CITY OF LA CAÑADA FLINTRIDGE

PLANNING COMMISSION STAFF REPORT July 11, 2017 Meeting

Case Type / Number:
Hillside Development Permit 17-19

Site Address:
4621 Indiana Avenue

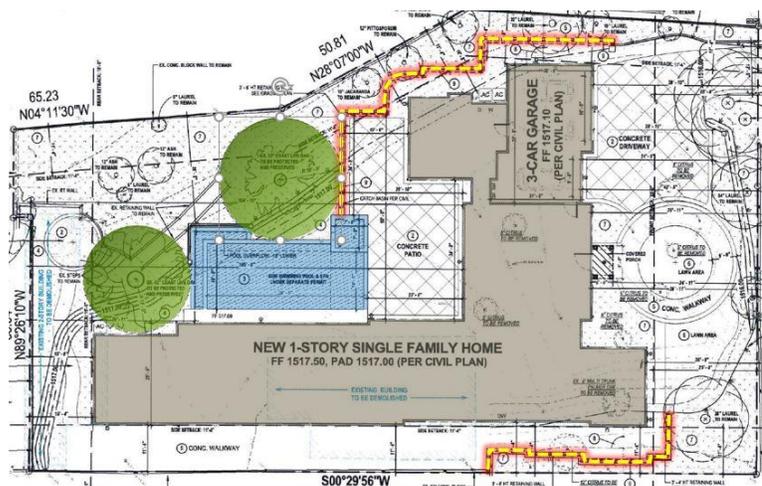
Increased pad height would contribute to overall building height. The 28-foot hillside **maximum would be satisfied around a majority of the home's perimeter.** An evaluation of proposed grades and structure height at the central portion of the front of the house suggests overall building height would exceed 28 feet, albeit minimally. However, the

area in question is limited to the home's highest ridge, which spans 30 feet in length but achieves a depth of only 6 feet. Its resulting qualification as an architectural extension exempts it from contributing to structure height. Again noting the roof's stepped form, average building height would be well within the 28-foot limit even when accounting for the raised pad level. Section "C" demonstrates this and has been revised to highlight natural grade, adjusted grade/pad level, the roof section in question and 28-foot height limit:

Should the Commission be concerned with the home's height, minor revision to any combination of finished grade level, plate height and/or roof pitch could eliminate the excess.

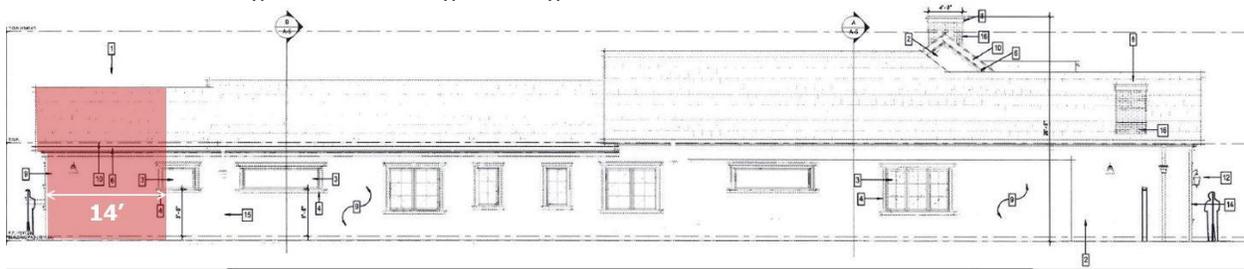
As mentioned, the home's employment of a single floor level would require some pad expansion to accommodate the footprint as proposed. This would be accomplished through construction of two new retaining walls along the east and west sides of the property. Rising grades would require use of a cut walls, inward-facing to the property, achieving a height of approximately 5 feet to the west and 6 feet to the east. The east wall would be lengthier, jogging to the north before returning to the west and terminating along the east end of a proposed spa, which would be flanked by a swimming pool and patio area. The top of this wall would accommodate the new drainage system comprised by a swale ①, subdrains ② and catch basins ⑦ as detailed on the conceptual drainage plan. As is customary, the project will require LID and more

Two large oak trees would be proximate, but are adequately separated from the new structures. The project has been reviewed and endorsed by a consulting arborist (report attached), subject to a number of protective measures. The grading plan indicates creation of soil berms^⑨ within the protection zones of trees 4 & 5, in attempt to yield consistent grades between the house and adjacent yard area. This seems to conflict with a note in the arborist report that prohibits fill soils along the trunk and the City's standard protection guidelines. As such, elimination of these berms and a portion of a concrete patio proposed along the rear property line is recommended.

A smaller "Palmer" oak tree near the southwest corner of the house would be removed. This tree was originally thought to be a 9" non-native specimen, but is actually a multi-trunk 19" tree that is native to southern California, albeit very sporadically. A Tree Removal Permit was not submitted as part of the original application, but is included as a condition of approval. **The home's footprint, retaining walls, pool/spa and subject oaks 4 & 5 are highlighted in the above diagram.**

16. Prior to submittal of the project for plan check, the grading plan shall be revised to eliminate the soils berms (fill) and circular concrete patio where within the protection zones of oak trees #4 and #5.
